Job:
RESIDENTIAL FLAT
BUILDING: - 1147, 1149
PACIFIC HWY & 2 BOBBIN
HEAD ROAD PYMBLE

BASEMENT LEVEL 1

SK04A

Job:
RESIDENTIAL FLAT
BUILDING: - 1147, 1149
PACIFIC HWY & 2 BOBBIN
HEAD ROAD PYMBLE
Drawing title:
**SECTION A-A',
SECTION B-B &
SECTION C-C'**
North point:

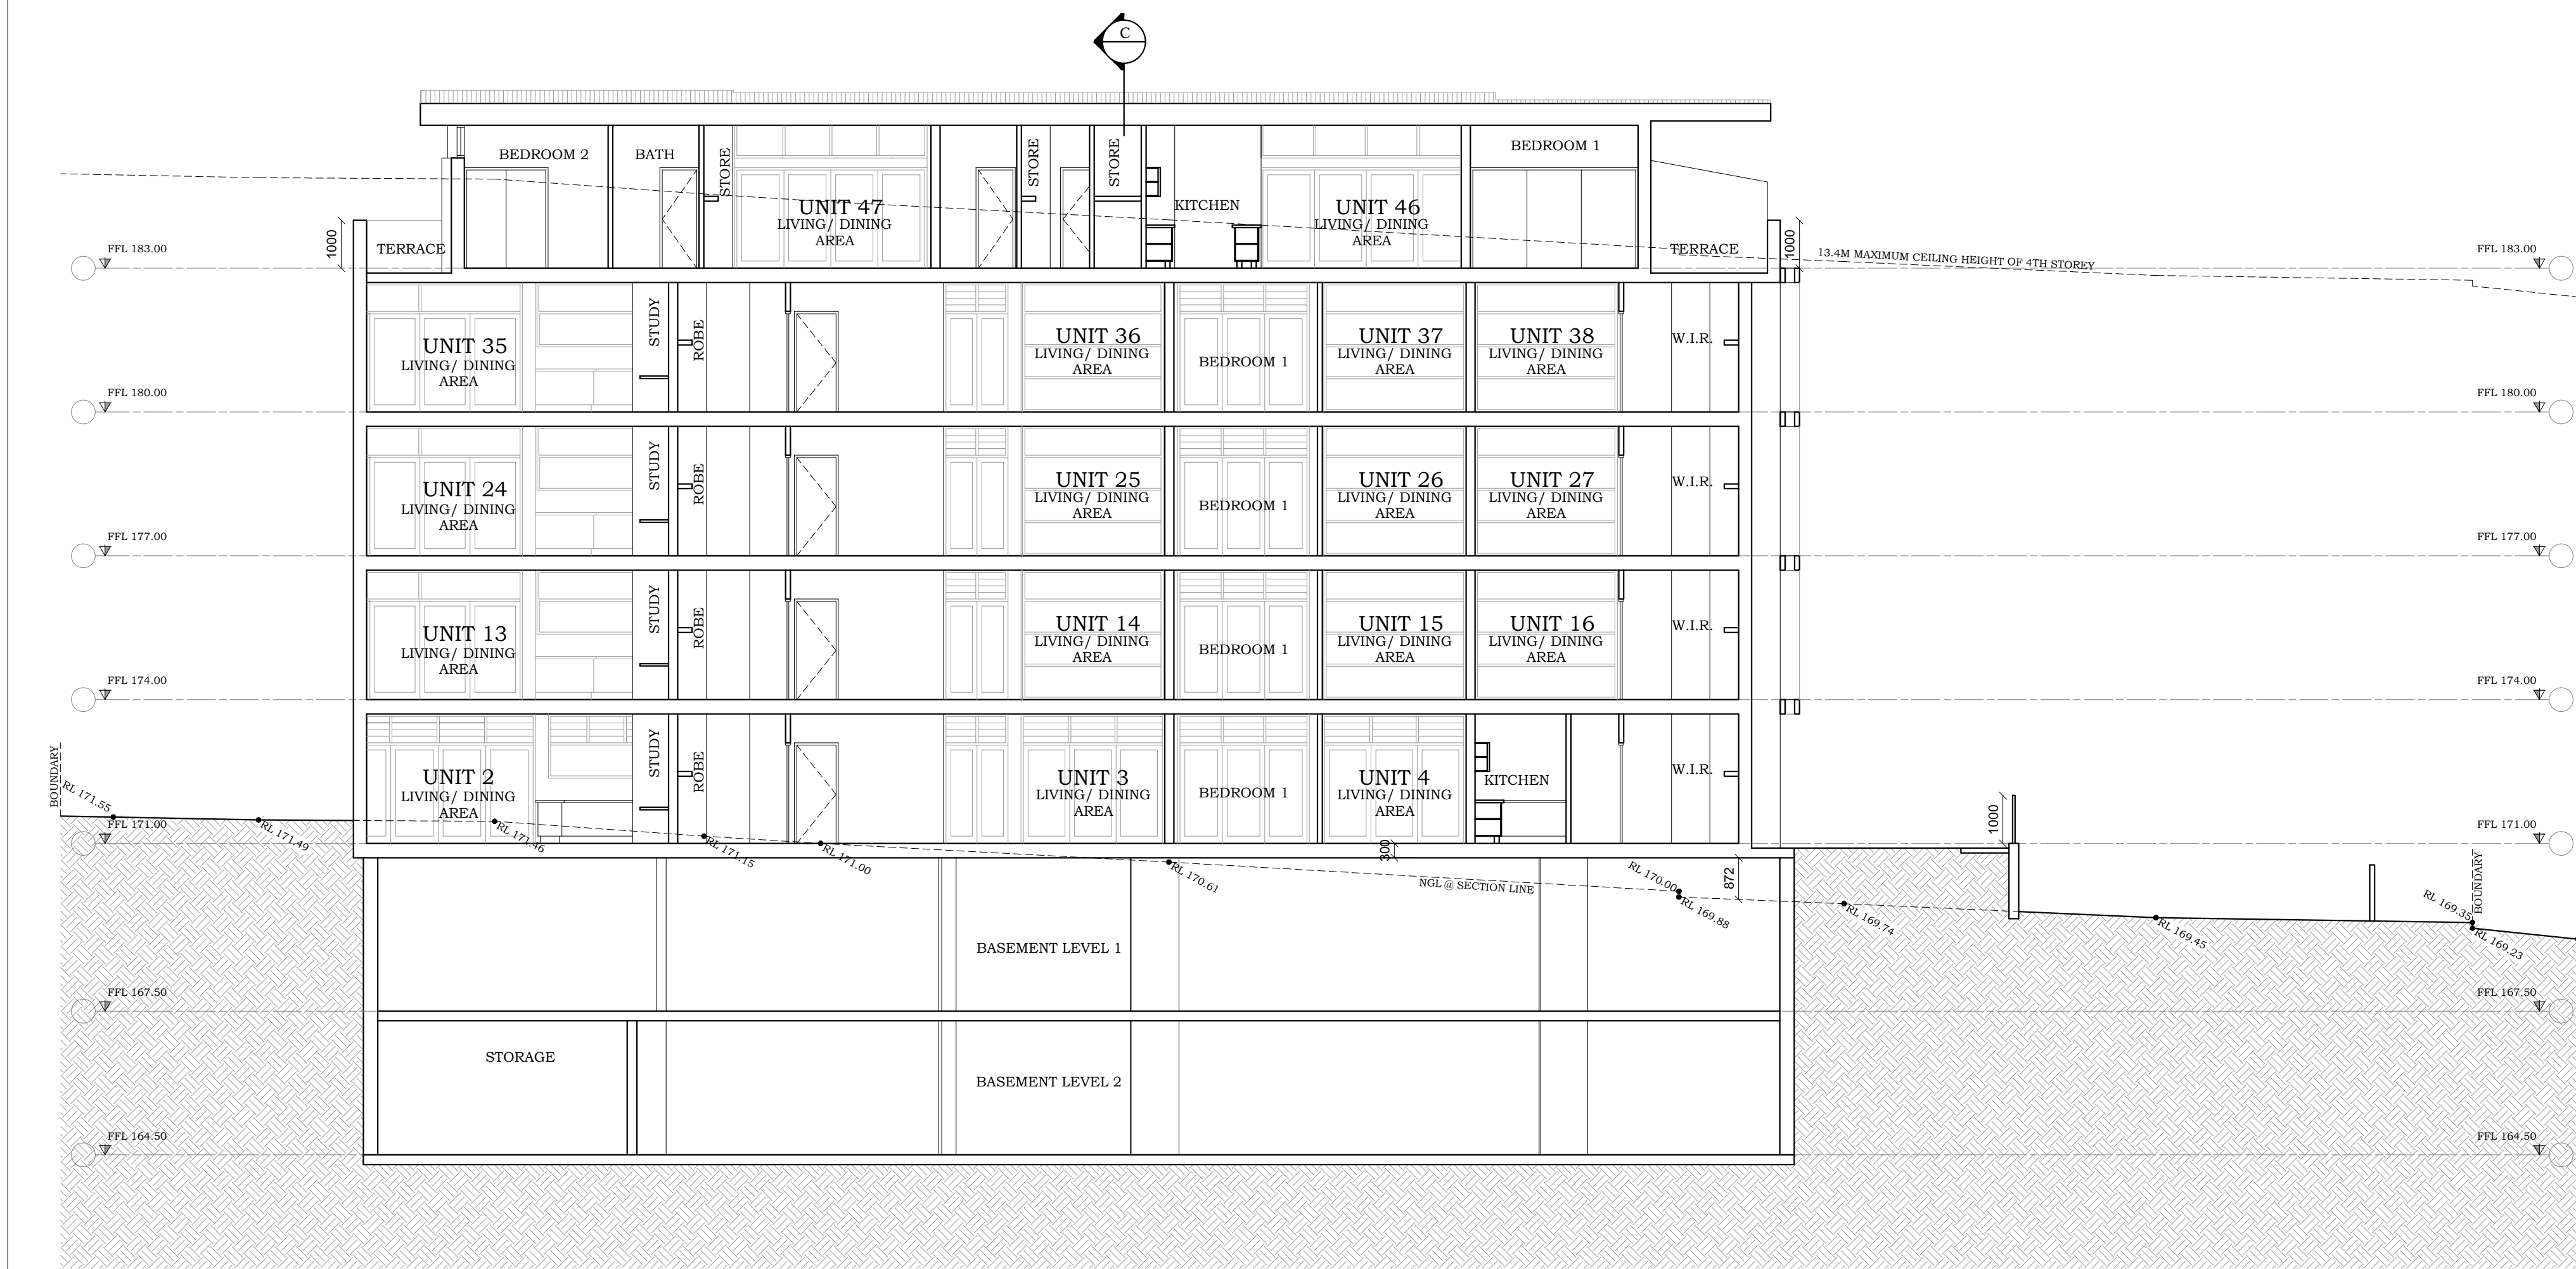
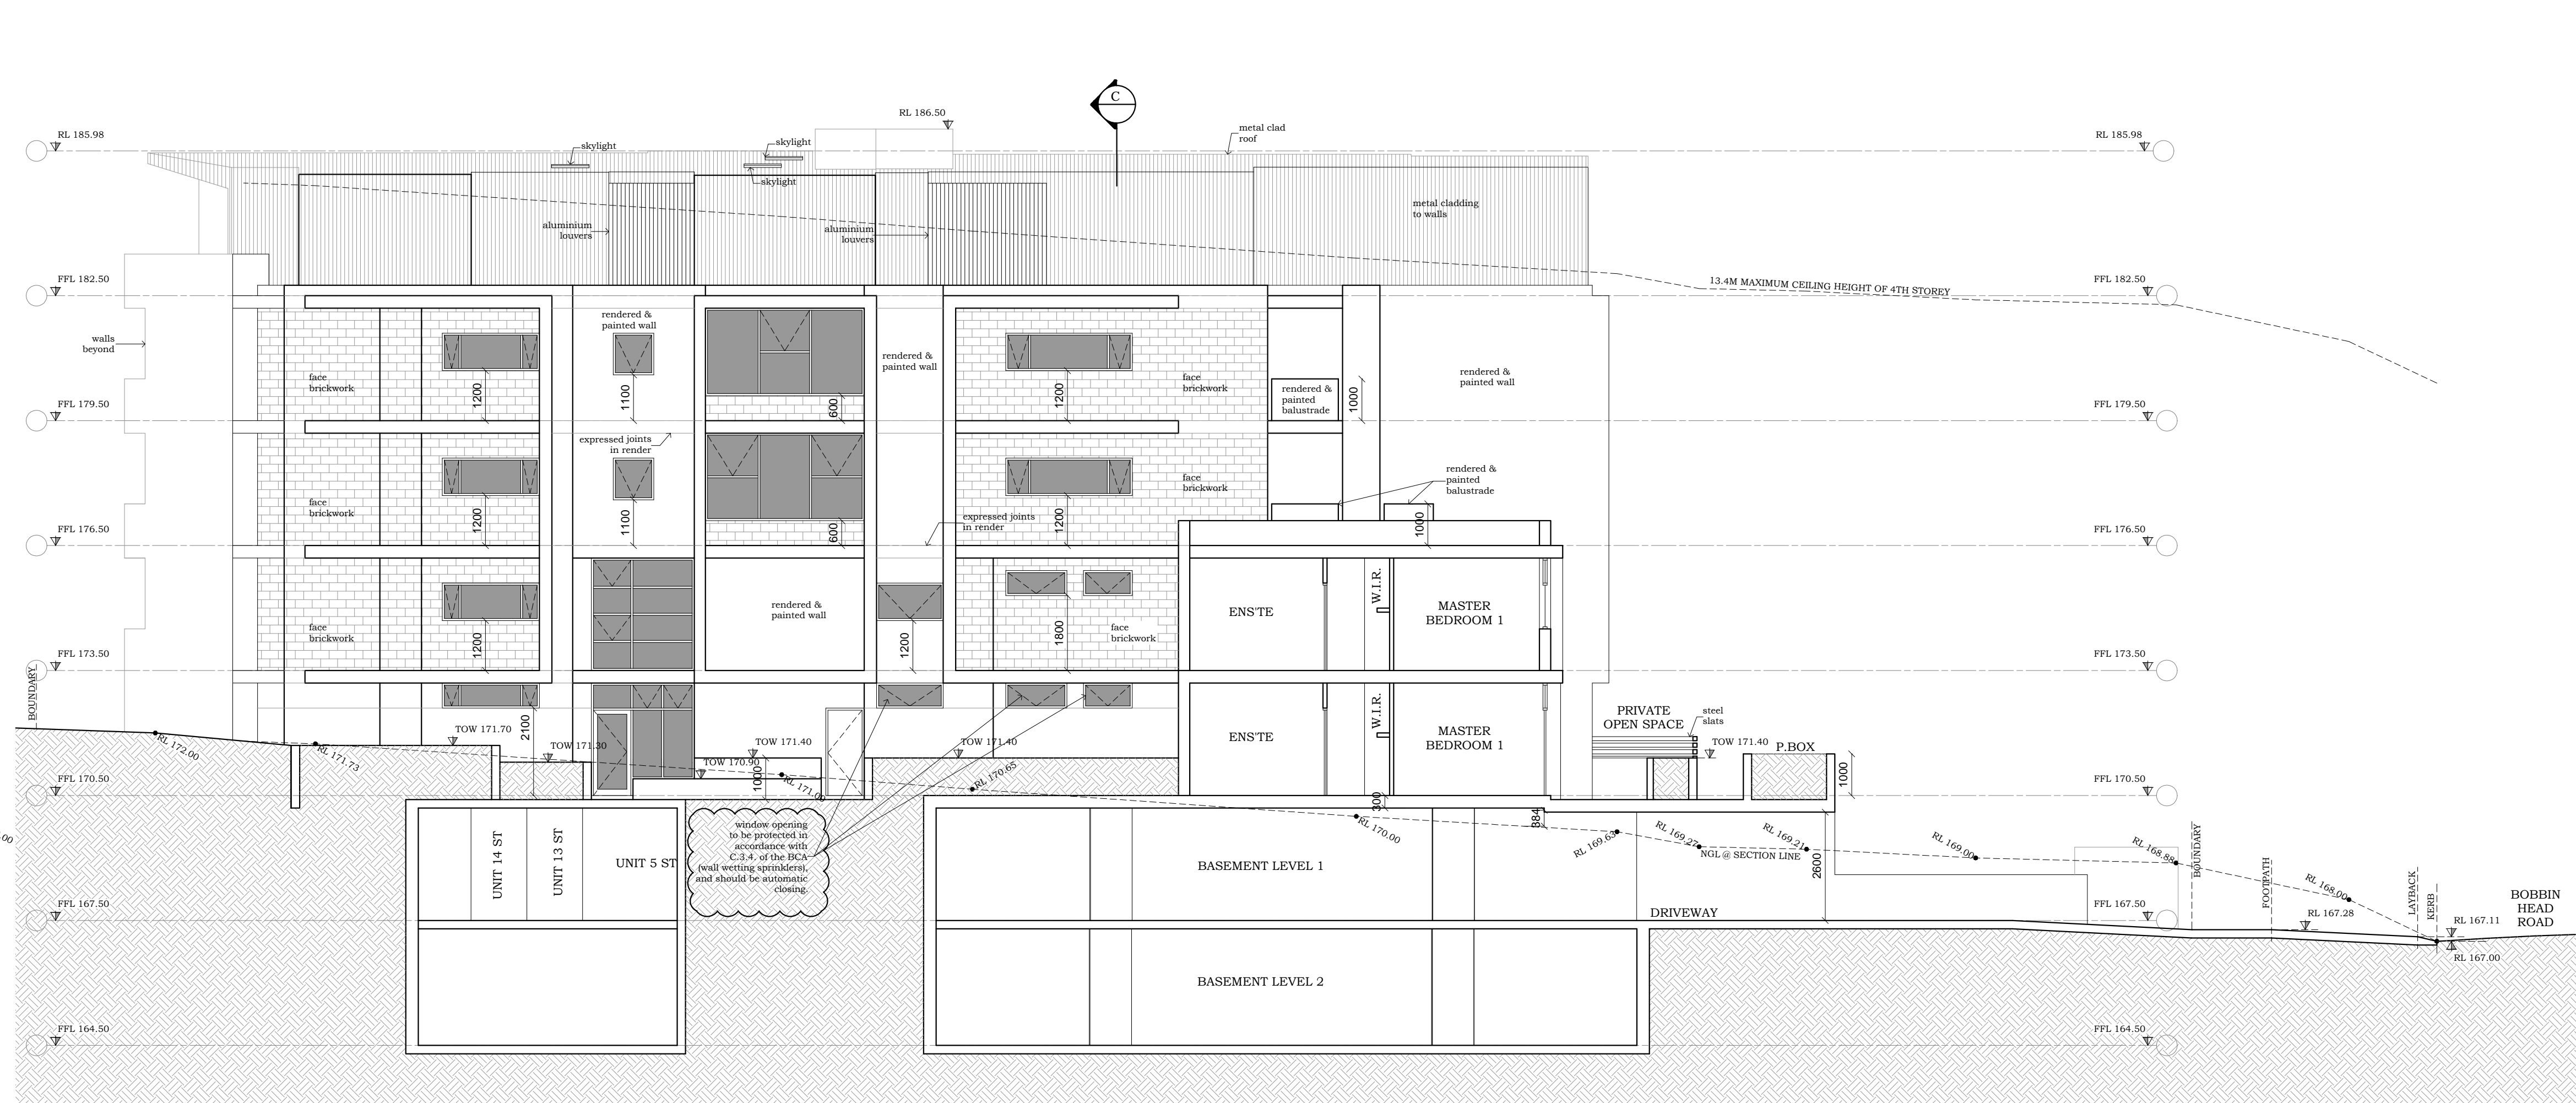
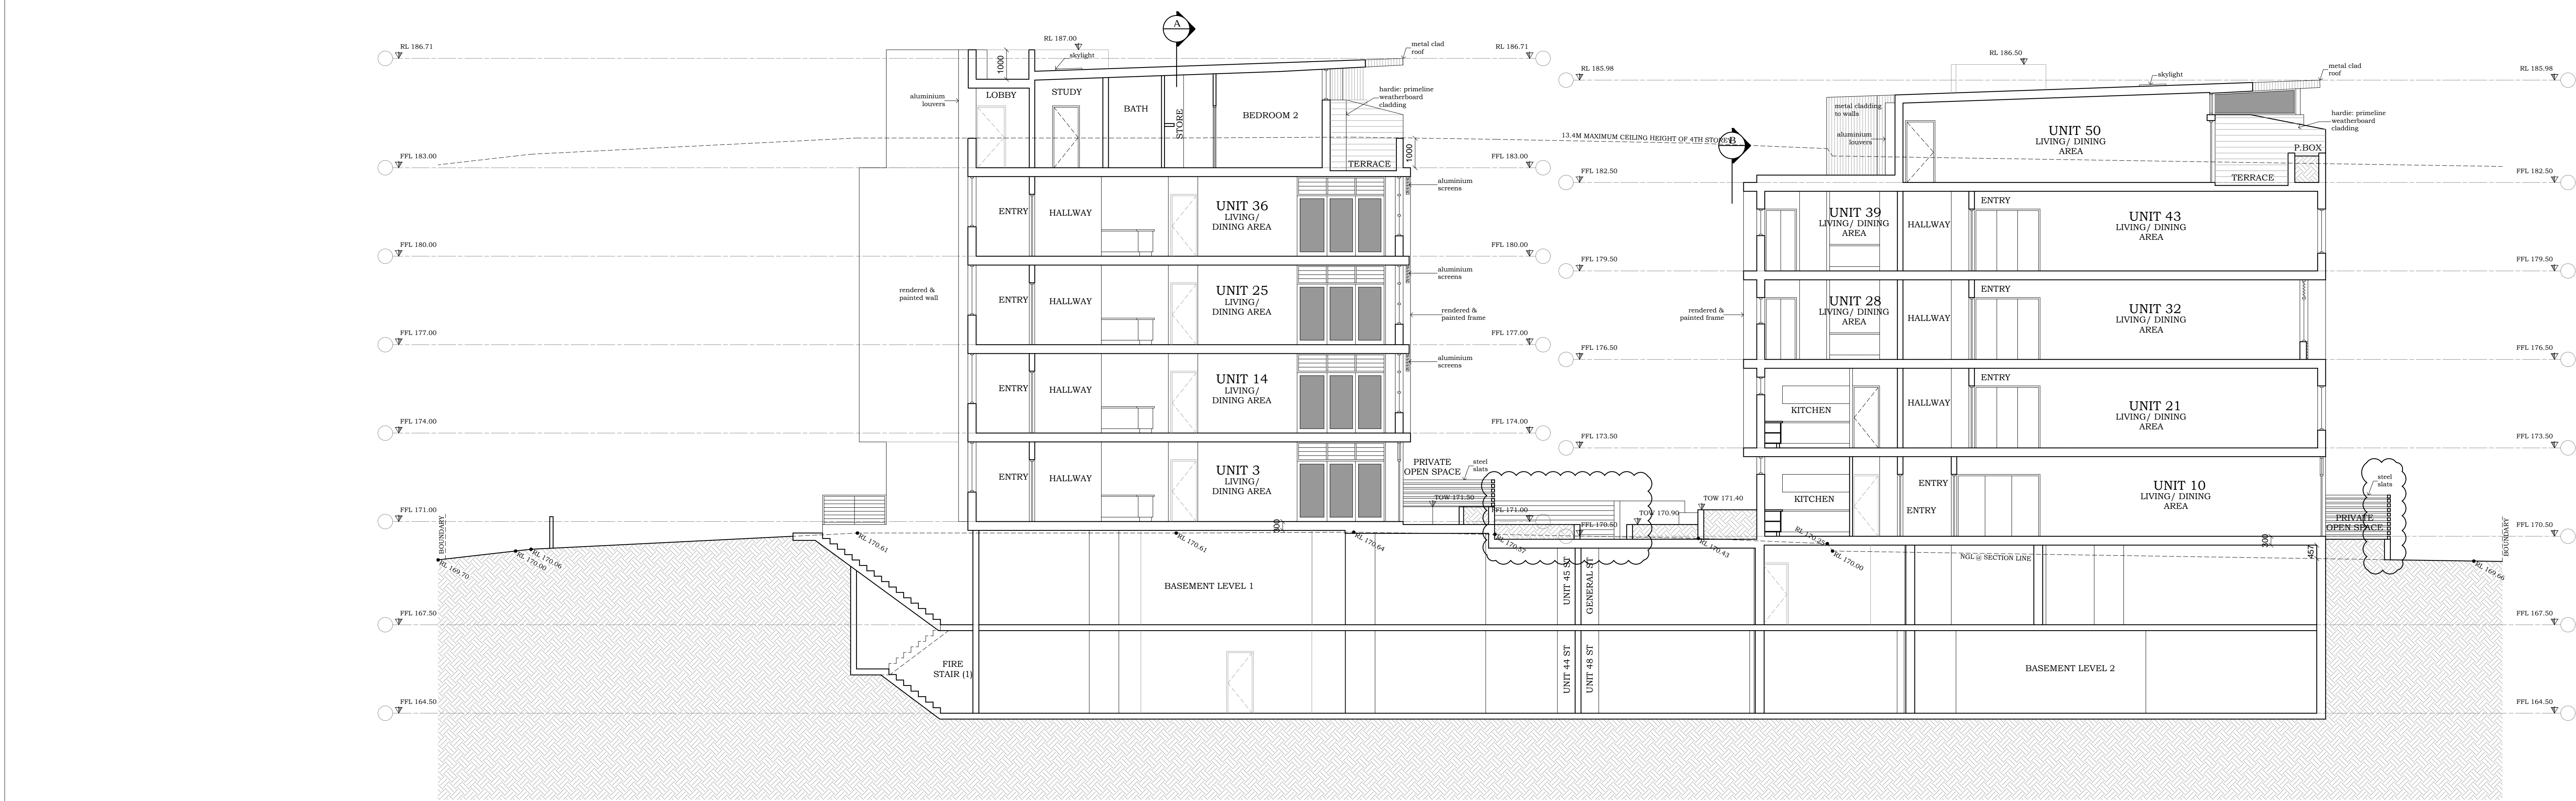
REV	AMENDMENTS	DATE
A	- the private courtyards adjacent to the northern boundary have been setback further from the northern boundary. - egress path has been amended adjacent to fire stair 2 & 4 so that more doors & windows are 6m away from the egress path	30.05.11
